UNITED STATES PATENT AND TRADEMARK OFFICE

APPLICATION NO.	FILING DATE	FIRST NAMED INVENTOR	ATTORNEY DOCKET NO.	CONFIRMATION NO.
10/025,821	12/26/2001	Satoshi Shinada	Q67781	4266

Office Action Summary

DETAILED ACTION

FIG. 1

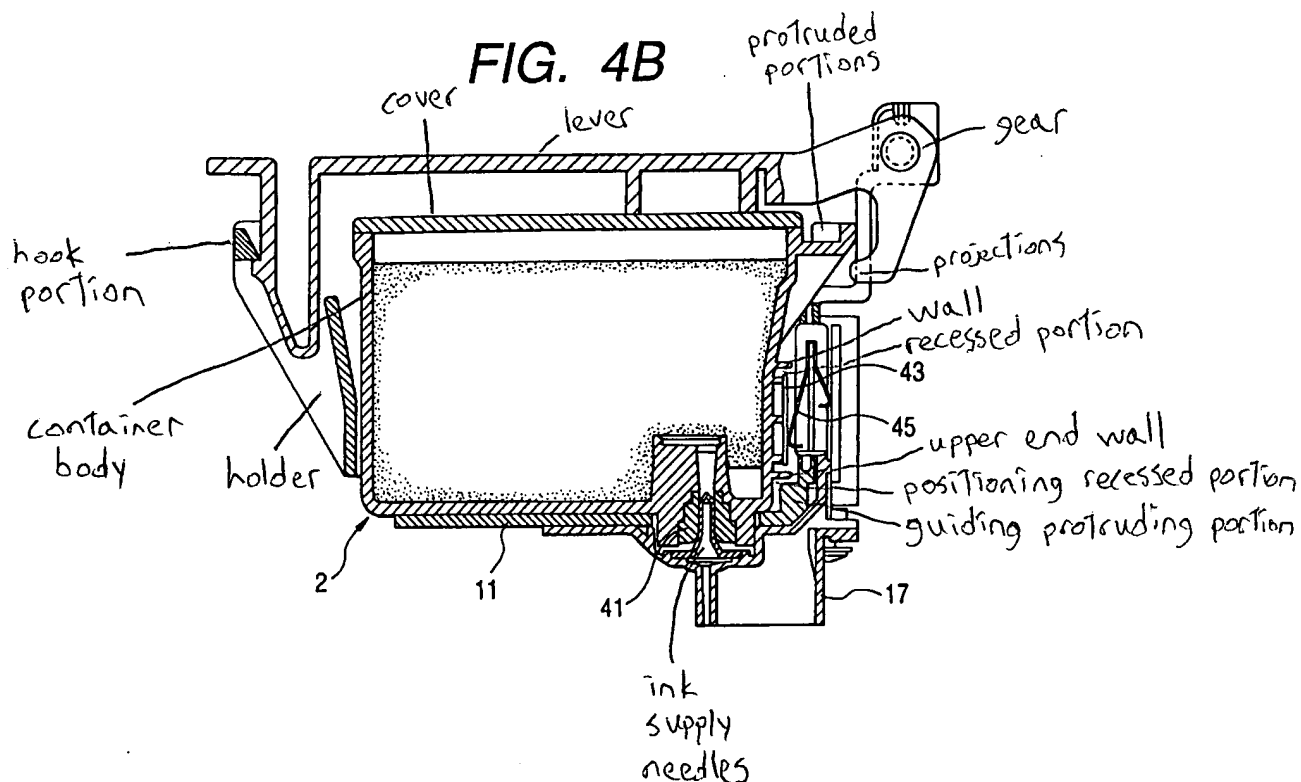
- {claim 1} An ink cartridge for an ink-jet recording apparatus (figure 1, references 1,2);

FIG. 4B

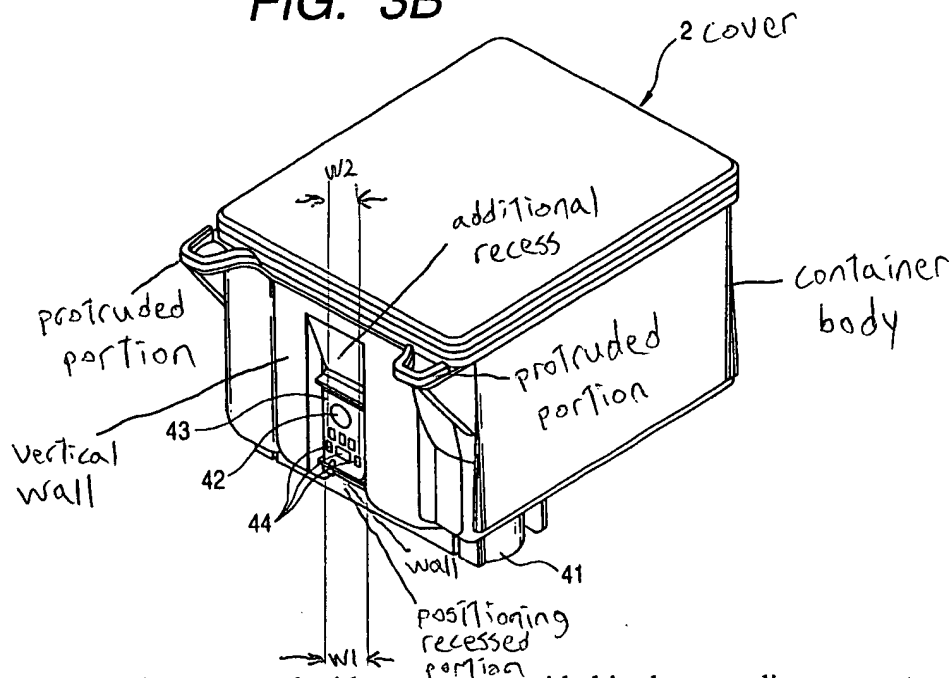
container body having an ink supply port (figure 4B, reference 41; container body drawn in);

- {claim 2} positioning system includes at least one recess that has an opening at a leading end thereof in an ink cartridge insertion direction, and that is engageable with the positioning member formed as a protrusion (figure 4B; positioning recessed portion, guiding protruding portion drawn in; it is seen that when the lever is lifted in a counter-clockwise direction around the gear, positioning recessed portion moves away from the guiding protruding portion; thus in the

- {claim 4} recess has an upper end wall to be contacted with an upper end of the protrusion (figure 4B; upper end wall drawn in)
- {claim 5} the wall extends in parallel to a direction in which the electrodes are arranged (figure 3B; wall drawn in between contact electrodes and positioning recessed portion; it is seen that the wall extends in parallel to a direction in which the electrodes are arranged)

- {claim 10} circuit board having the electrodes is accommodated in a recessed portion formed in the container body (figure 4B, references 43, 45)

- {claim 11} the positioning recessed portion is formed at a position below a circuit board having the electrodes (figure 4B, references 43, positioning recessed portion)

- {claim 13} the container body has a recessed portion for accommodating a circuit board having the electrodes, and has a wall which defines the recessed portion and is brought into contact with a top surface of the protruding portion (figure 4B, reference 43, 45, upper end wall, positioning recessed portion, guiding protruding portion)

Fig. 5

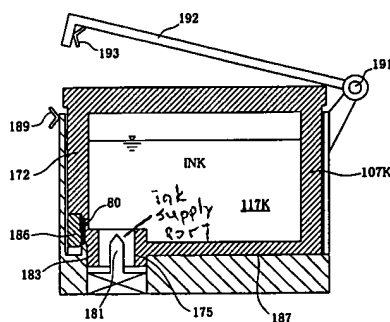
- {claim 1} An ink cartridge for an ink-jet recording apparatus (figure 5, reference 107K);

container body having an ink supply port (figure 5; reference 107K); a storage element disposed on the container body (figure 5, reference 80); electrodes to be contacted with contacts provided in the recording apparatus accommodating the container body therein (figure 4B, references 185, 186; column 12, lines 9-13);

Fig. 16

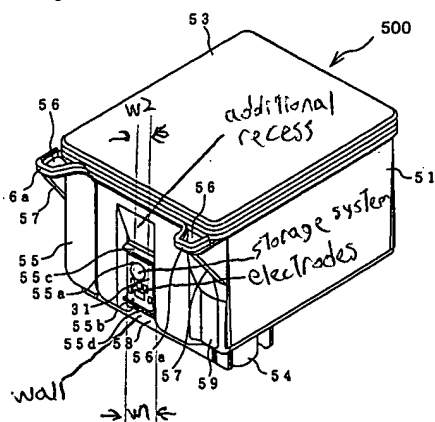
- {claim 3} the at least one recess includes a pair of recesses located opposite from each other with respect to the electrodes (figure 16, reference 58; additional recess drawn in)

- {claim 5} wall extends in parallel to a direction in which the electrodes are arranged (figure 16, reference 58; wall and electrodes drawn in; wall drawn in between electrodes and recess 58; it is seen that the wall extends in parallel to a direction in which the electrodes are arranged)
- {claim 6} a contact area between the wall and the positioning member is wider than a width of an area in which the electrodes are arranged (figure 16; the width of the area between the wall and the positioning member is [W1] and the width of the area in which the electrodes are arranged [W2] are drawn in; it is seen that $W1 > W2$)

- {claim 8} the storage element and the electrodes are mounted on a same flexible cable (figure 16; storage system and electrodes drawn in)
- {claim 9} an ink cartridge for an ink-jet recording apparatus, comprising: a container body having an ink supply port; electrodes; a storage element (as taught above)

- {claim 10} circuit board having the electrodes is accommodated in a recessed portion formed in the container body (figure 16, reference 31)
- {claim 11} positioning recessed portion (i.e. recess 58) is formed at a position below a circuit board having the electrodes (figure 16, references 31, 58, electrodes)

- {claim 13} the container body has a recessed portion for accommodating a circuit board having the electrodes (figure 16, references 58, wall, electrodes)

- {claim 16} the storage element is mounted on a circuit board (figure 16; storage element drawn in)
- {claim 17} a flexible cable is connected to a circuit board having the electrodes, and the storage element is connected to the electrodes through the flexible cable (figure 16; column 12, lines 9-13; column 23, lines 58-65)
